AMENDMENTS TO THE DRAWINGS

REMARKS

Fig. 15

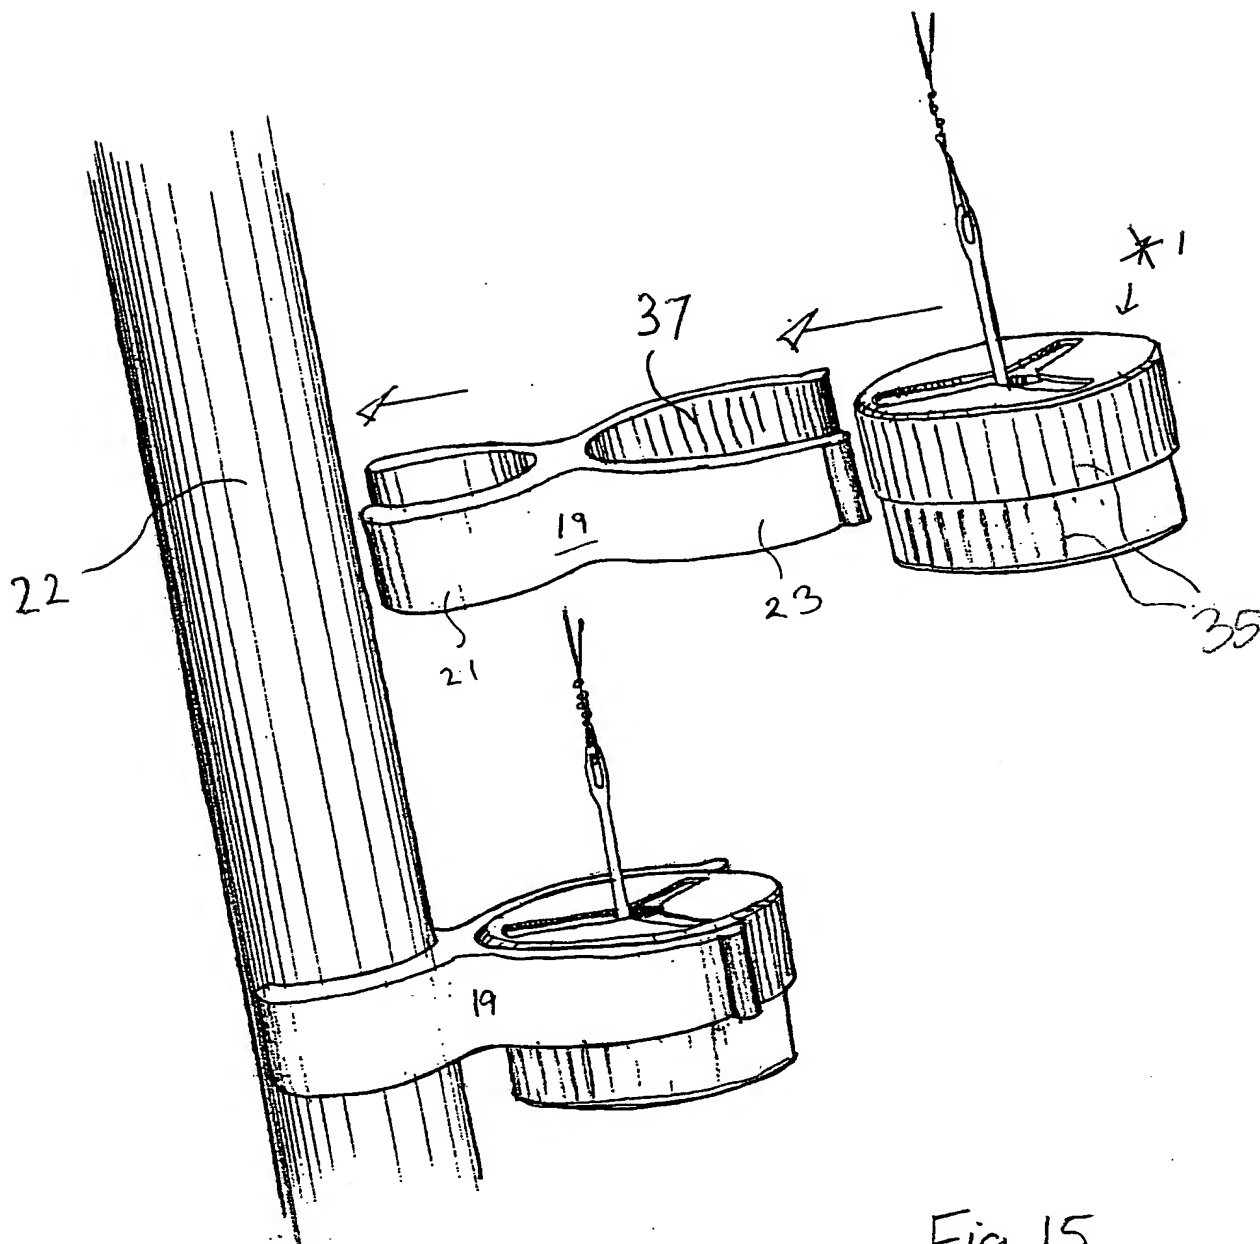
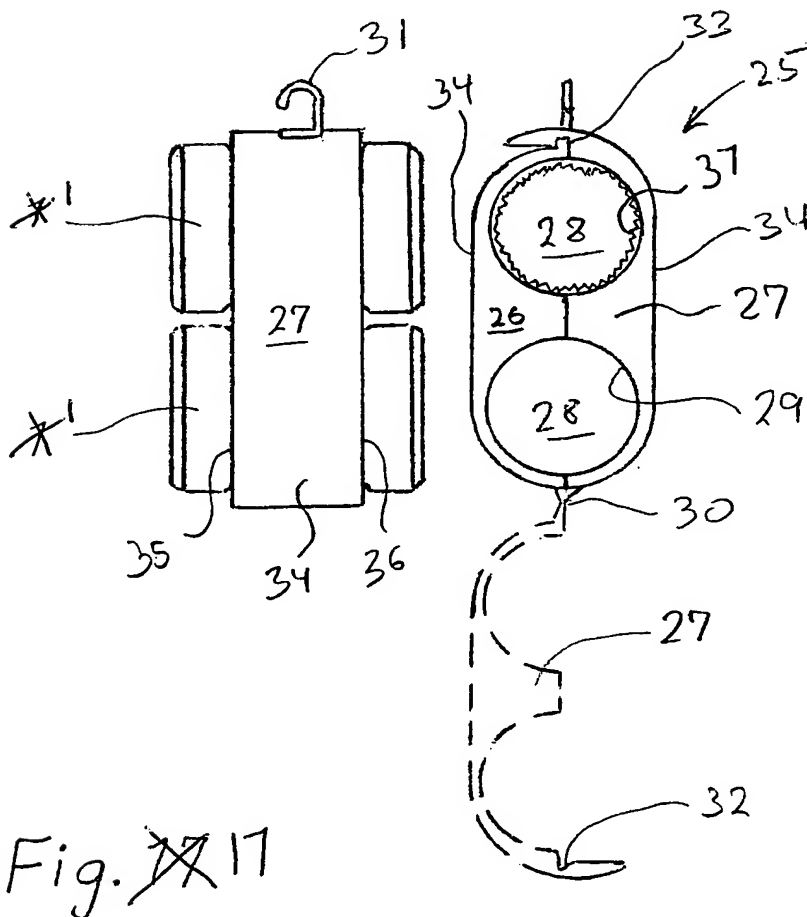
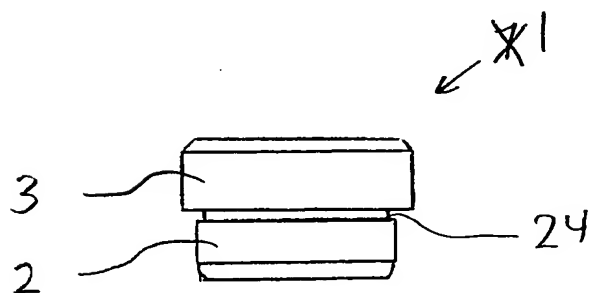
The attached sheets of drawings include changes to Figs. 1-6 and 8-17. These sheets, which include Figs. 1-17, replace the original sheet including Figs. 1-17. In Figs. 1-17 ribs 37 and pin 39 are shown, and confusion between “1” and “7” is avoided.

The drawings are objected to under 37 CFR 1.83(a). We have amended them to show the pin, the elongate slot and the longitudinal grooves (claim 15) and to distinguish clearly between the reference numerals 1 and 7. Reference numerals added to the drawing have also been added to the specification. No new matter is entered. Withdrawal of the objection to the drawings is therefore respectfully requested.
